Informal Document No. GRE-64-56
(64th session, 4-7 October 2010,
agenda item 9)

64th GRE Session
Proposal for amendment of R 10.03
TRANS-WP29-GRE-2010-54e

Proposal from
France and Germany

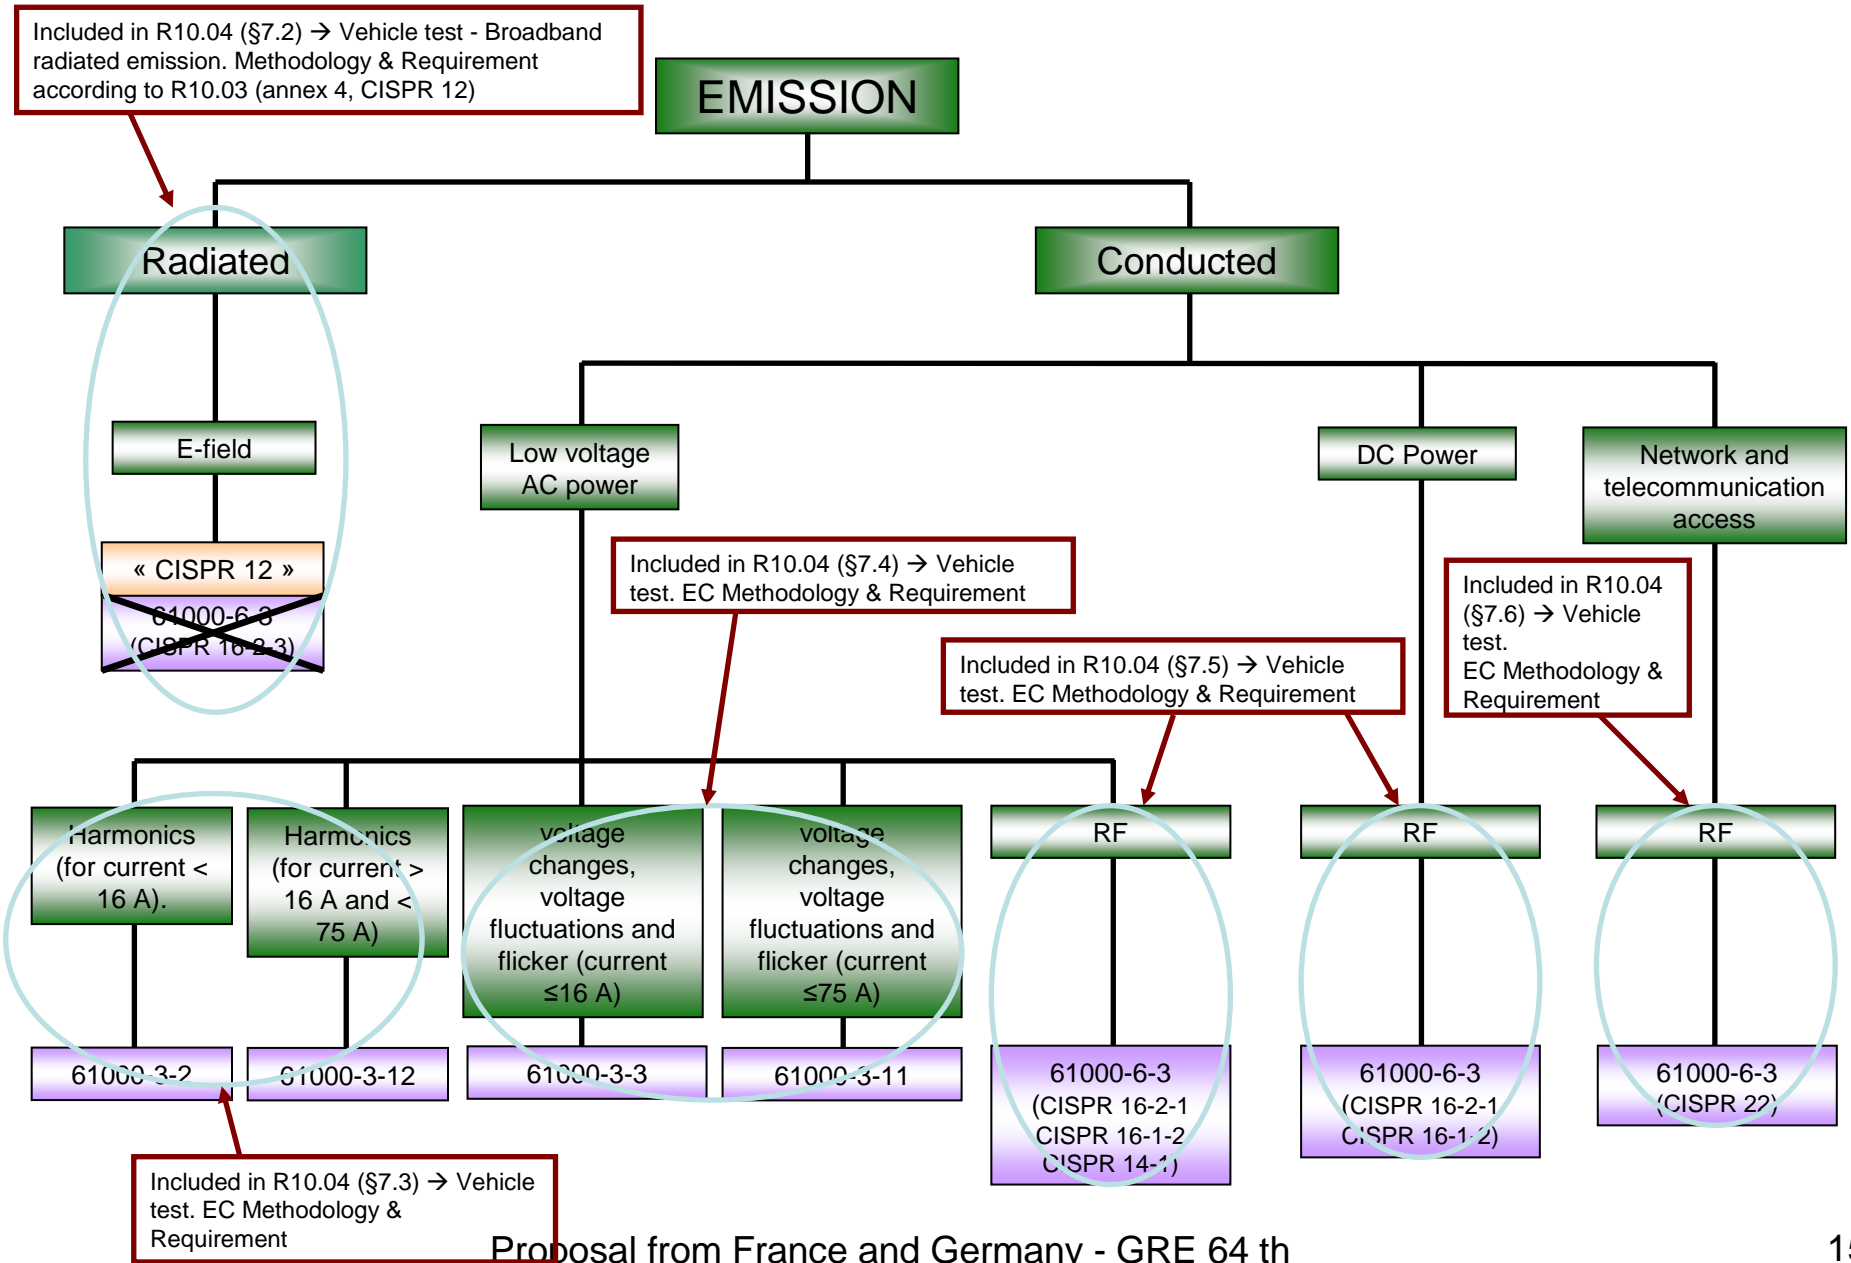
- ⚡ To take into consideration **FOR EMISSION** of EV and HV in charging mode **both the generic emission standard IEC 61000-6-3 for residential environment and the automotive CISPR emission standards :**
 - ✓ **CISPR 12 standard** for broadband radiated emission (E-field outside the vehicle)
 - ✓ **IEC 61000-X-X standards** for all other emission tests

This approach leads to :

- ✓ **5 new paragraphs concerning emission** in new paragraphs: **7.2** concerning CISPR standards and **7.3 to 7.6** concerning IEC standards.
- ✓ **1 updated annex (4)** concerning CISPR standards
- ✓ **4 new annexes (11 to 14)** concerning IEC standards

Revision of ECE 10 – Electric and Hybrid vehicles

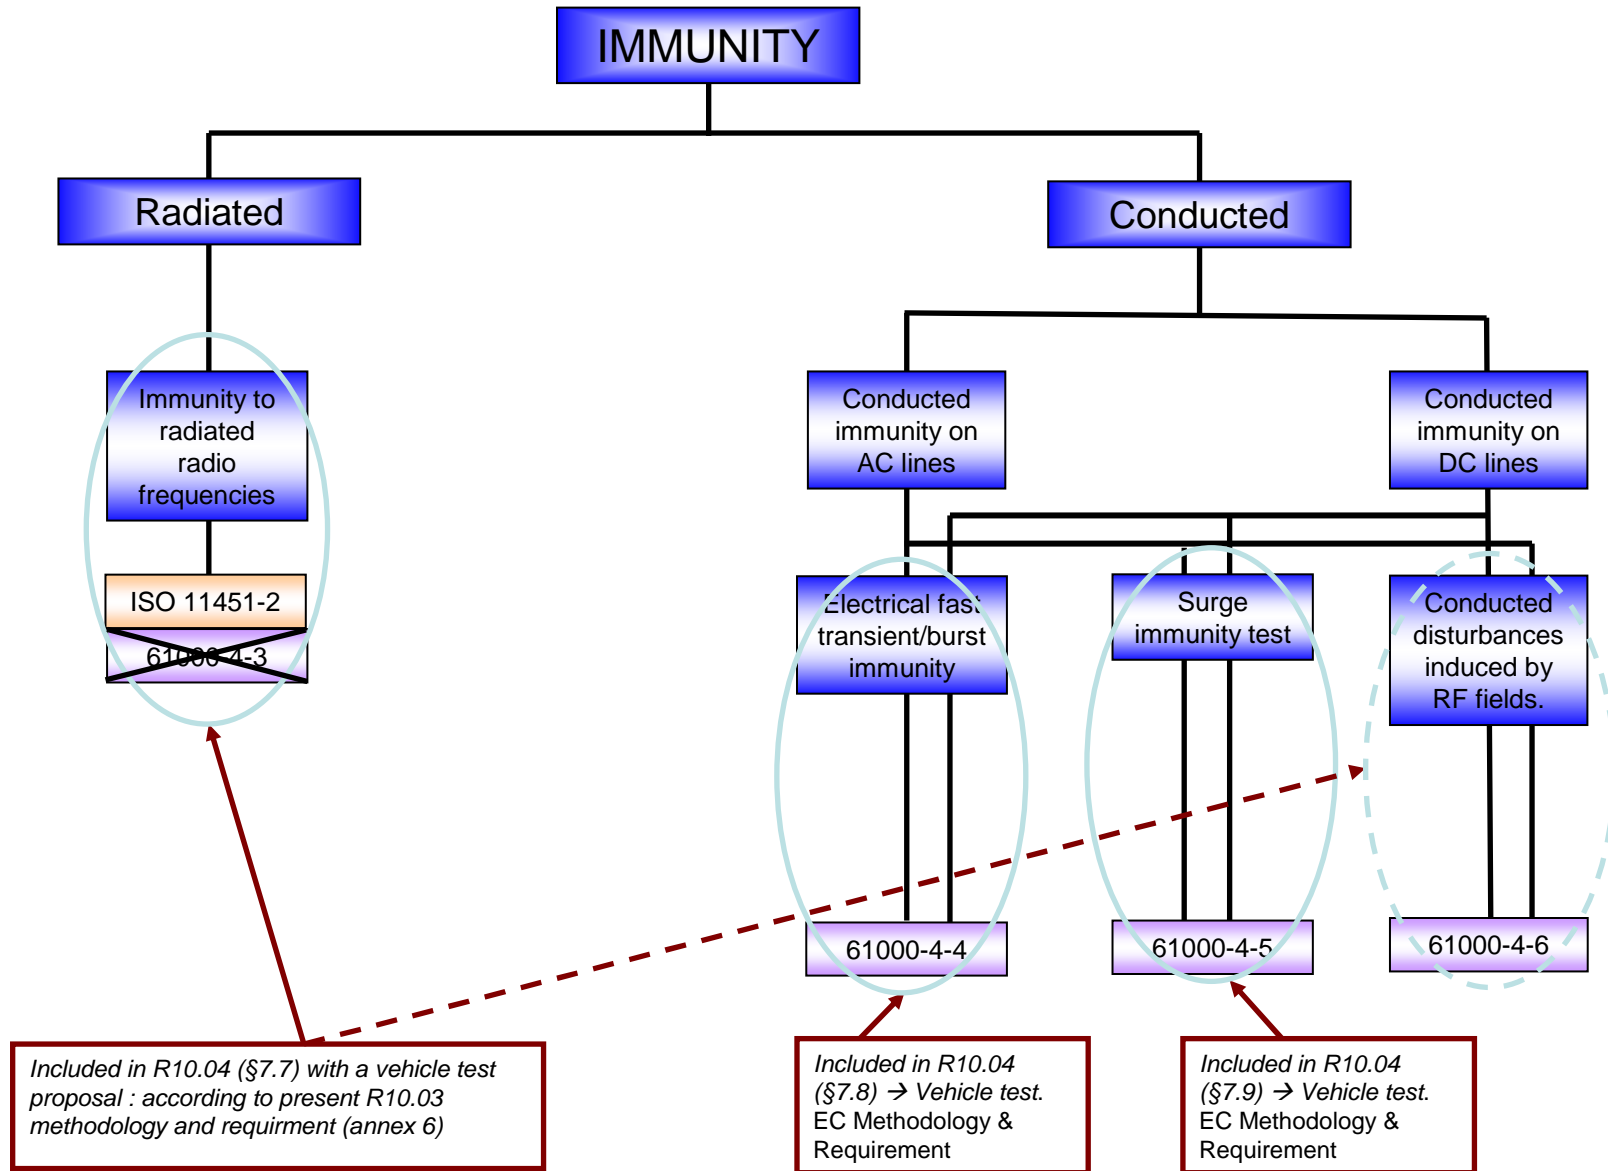
- ⚡ To take into consideration **FOR IMMUNITY** of EV and HV in charging mode both the generic immunity standard IEC 61000-6-2 for industrial environment and the automotive ISO/TC22/SC3/WG3 immunity standards :
 - ✓ ISO 11451-2 standard for radiated immunity to external sources
 - ✓ IEC 61000-4-X standards for all other immunity tests

This approach leads to :

- ✓ 3 new paragraphs concerning immunity in new paragraph 7: 7.7 concerning ISO/TC22/SC3/WG3 standards and 7.8 to 7.9 concerning IEC standards.
- ✓ 1 updated annex (6) concerning ISO/TC22/SC3/WG3 standards
- ✓ 2 new annexes (15 to 16) concerning IEC standards
